Exhibit A1
Staff Report
Frog Pond Ridge 71-Lot Single-Family Subdivision

Development Review Board Panel 'A'
Quasi-Judicial Public Hearing
Amended and Adopted August 31, 2020
Added language **bold italics underline**
Removed language ~~struck through~~

Application Nos.: DB20-0007 Annexation
DB20-0008 Zone Map Amendment
DB20-0009 Stage I Preliminary Plan
DB20-0010 Stage II Final Plan
DB20-0011 Site Design Review of Parks and Open Space
DB20-0012 Tentative Subdivision Plat
DB20-0013 Type C Tree Removal Plan
DB20-0014 Waiver - Front Setback
SI20-0001 Abbreviated SRIR Review

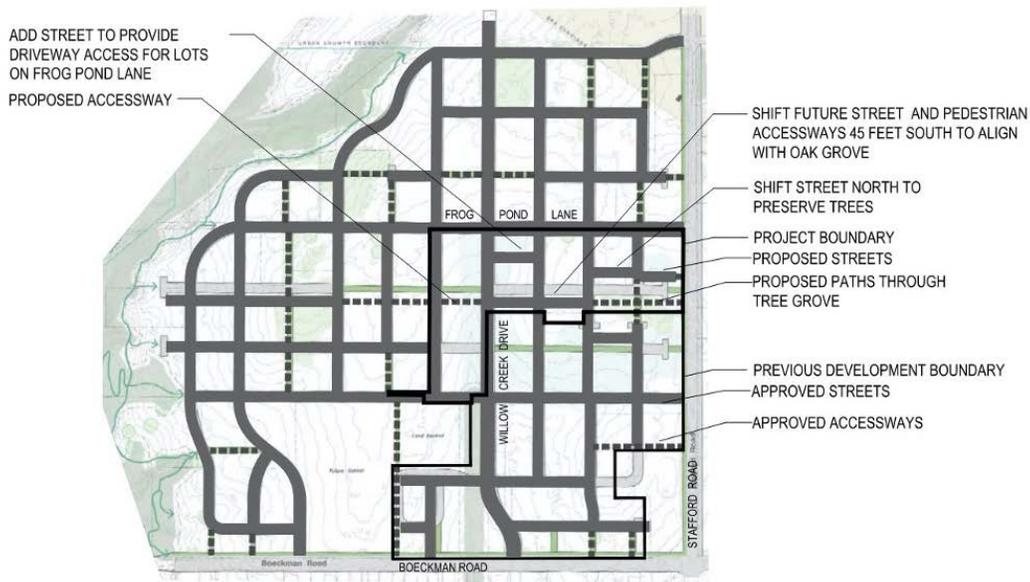
reasons, it is not practical to place street trees and streetlights in stormwater swales. As directed by the City, the applicant's plans prioritize street tree and street lighting placement with appropriate spacing from utility laterals and water meters, then places stormwater facilities where space remains available and placement is desirable.

Block, Access, and Connectivity Consistent with Frog Pond West Neighborhood Plan
Subsection 4.127 (.10) and Figure 18. Frog Pond West Master Plan

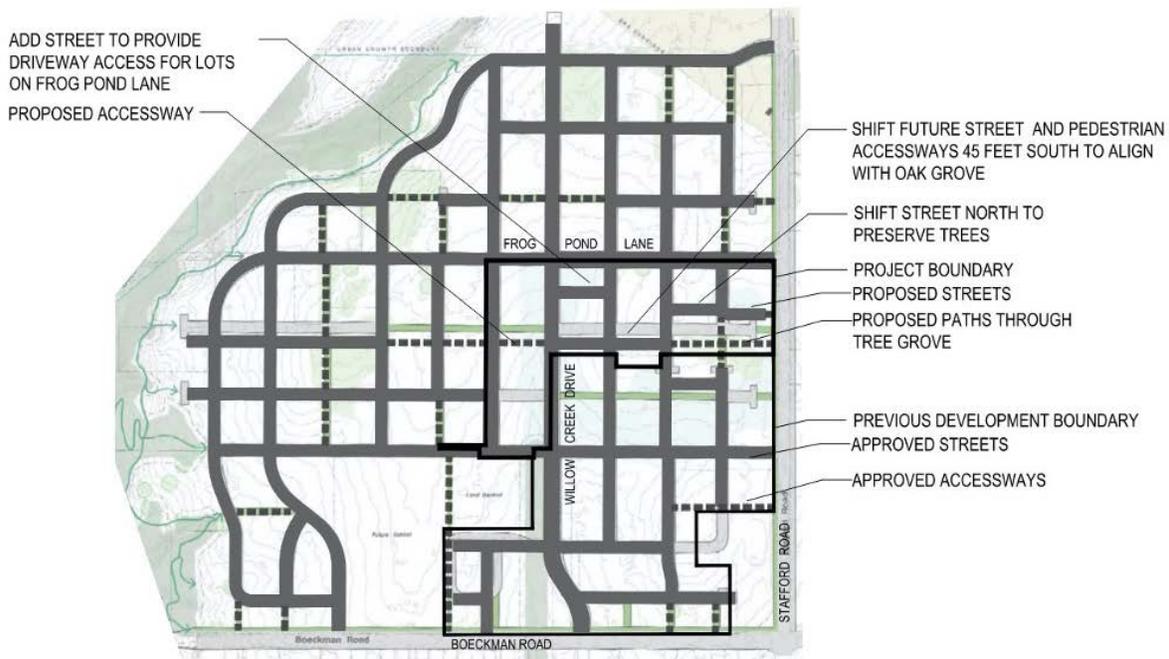
D15. The Street Demonstration Plan (Figure 18 of the Frog Pond West Master Plan), is an illustrative layout of the desired level of connectivity in the Frog Pond West neighborhood. The Street Demonstration Plan is intended to be guiding, not binding, allowing for flexibility provided that overall connectivity goals are met.

In order to achieve minimum density requirements while providing access throughout the subdivision, the applicant proposes some limited variations from the Street Demonstration Plan that results in a modified grid configuration of streets. As shown in the illustration and summarized below, the applicant proposes to eliminate an east-west

Consistency of the proposed modifications with Figure 18 is summarized and illustrated in the diagram below:

- North-South Alignments, from west to east:
 - Street I: Alignment generally consistent with Figure 18.
 - SW Willow Creek Drive: Alignment generally consistent with Figure 18.

- SW Larkspur Terrace: Alignment generally consistent with Figure 18.
 - SW Marigold Terrace: Alignment generally consistent with Figure 18.
 - Street H: Alignment generally consistent with Figure 18.

- East-West Alignments, from south to north:
 - SW Brisband Street: Alignment generally consistent with Figure 18.
 - East-West Street, North of SW Brisband Street: Alignment not provided as shown on Figure 18.

- Tracts A and E Pedestrian Connections, Streets K and L, and Tract G Private Street: Alignment generally consistent with Figure 18. Tract A pedestrian connection between Street I and SW Willow Creek Drive and Street K alignment shifted 45 feet south to align with Tract E pedestrian connection through oak grove. Street L and Tract G Private Street alignment shifted north to preserve trees in oak grove.

- Street M: New street not shown on Figure 18. Alignment added to provide driveway access for Lots 28-31 that back to SW Frog Pond Lane.
